Council Comments - SSD-76220734 - 156-164 Ocean Street, Narrabeen

Appendix 1 Northern Beaches Council Submission - Detailed Supplementary Comments - SSD-76220734 - 156-164 Ocean Street, Narrabeen

Loading/ Servicing

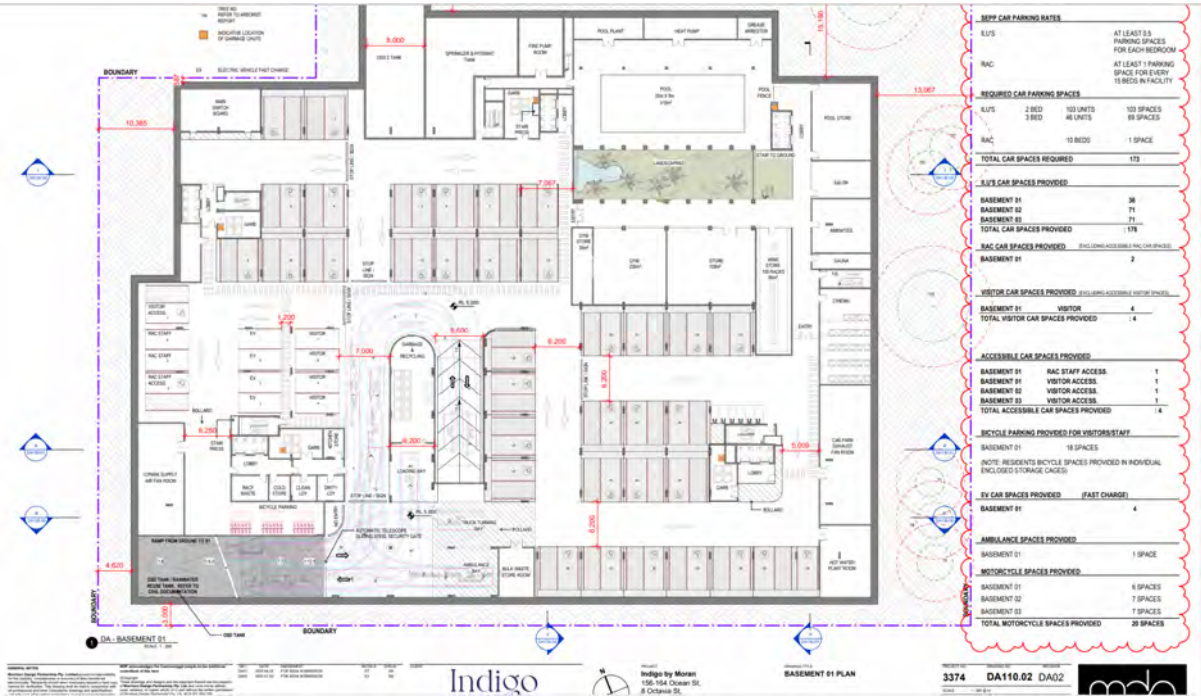
The development should cater for servicing of waste by a 10.5m waste collection vehicle. The loading bay appears to be sized only to accommodate a small rigid vehicle which is considered inadequate for a development of this scale. Turning and overhead clearance (4.5m) for access by a vehicle of this size must be demonstrated.

Apart from waste collection it is considered unlikely that all other servicing needs will be completed by SRVs or mini vans. Removalist trucks will be required on a regular basis for a development comprised of 149 ILU's and 10 aged care beds. Off-street parking for at least a MRV to facilitate access for removalist trucks and other large servicing vehicles, in addition to the loading bay for garbage and recycling is considered necessary.
